☐ as drawn ■ as redlined

PROPOSED:
ST. CLARE PLACE
1149A 3RD (2ND) AVENUE EAST
Owen Sound, N4K6P5

Drawing Name:
SITE PLAN

Layout ID: A-001

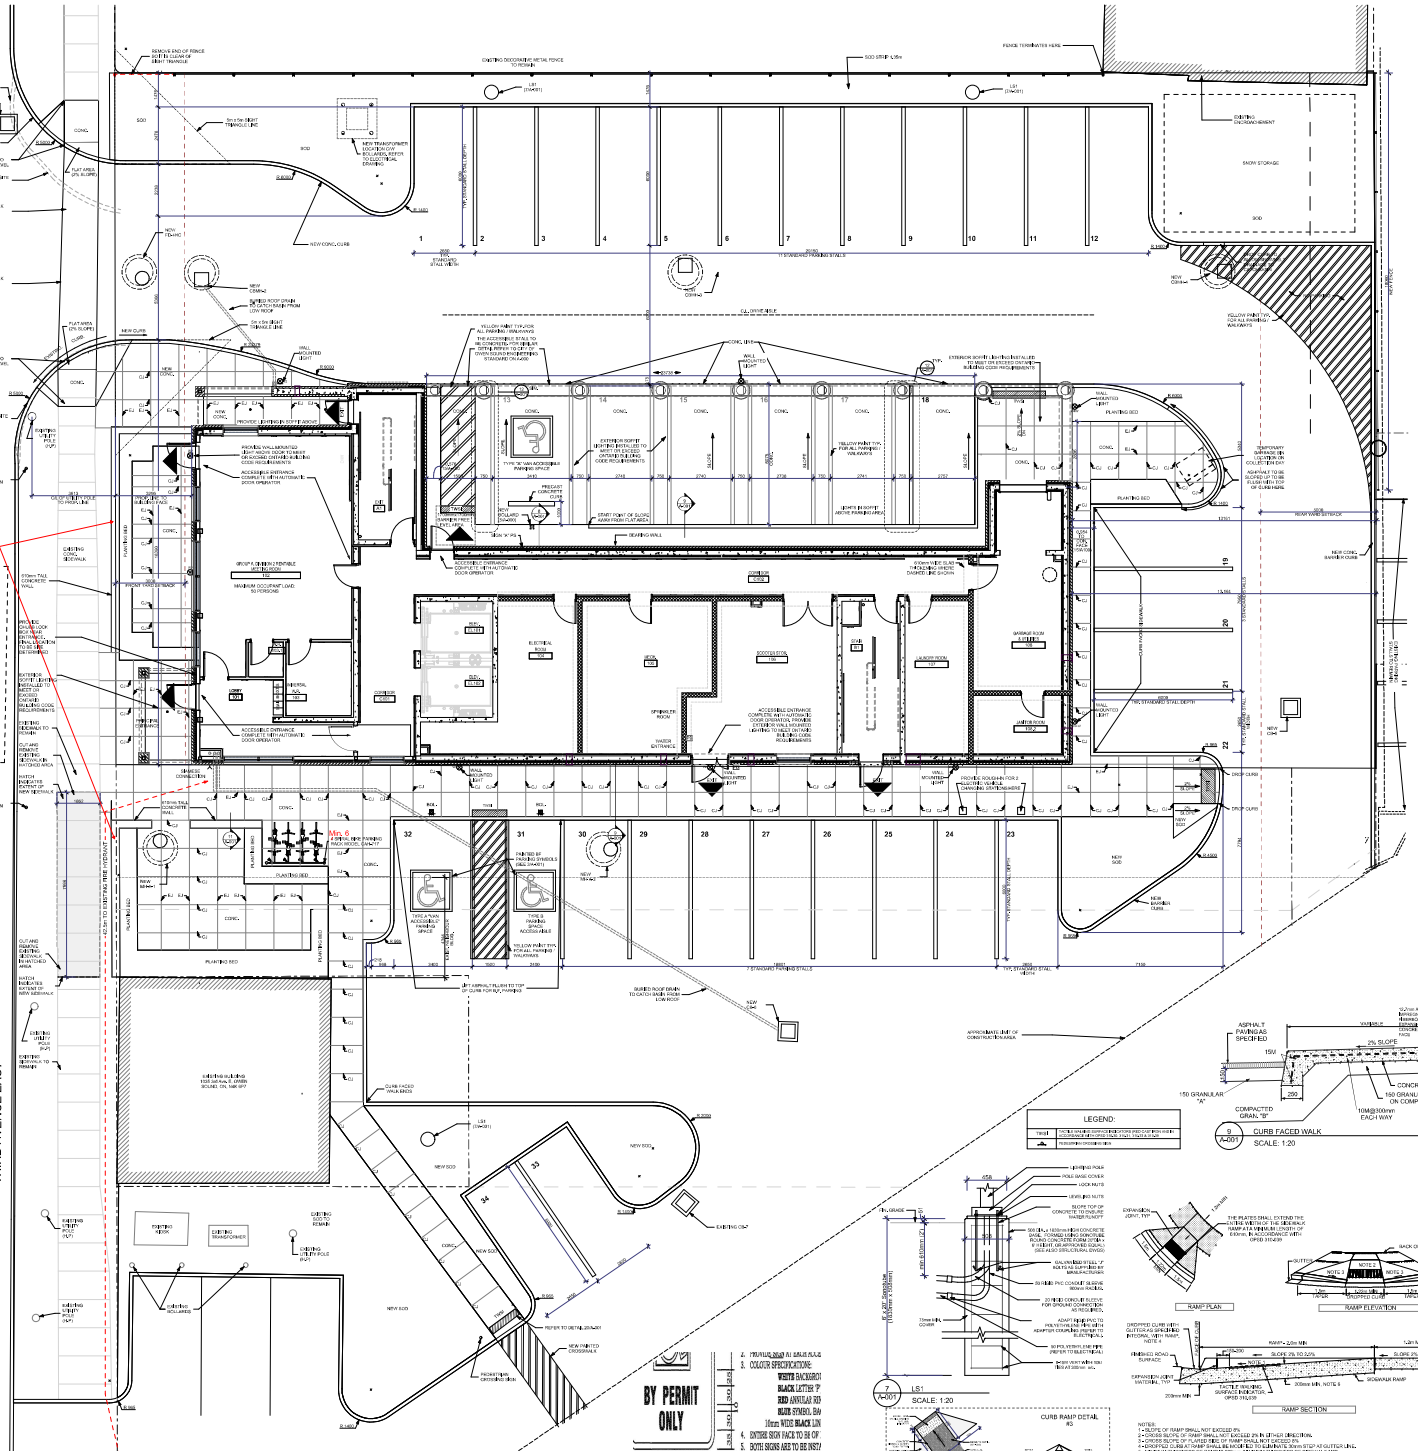
Relocate planting bed wall to private property ~0.3 m clearance from lot line. The planting bed shall have a cane detectable edge installed where it abuts a pedestrian pathway of travel, in accordance with AODA requirements.
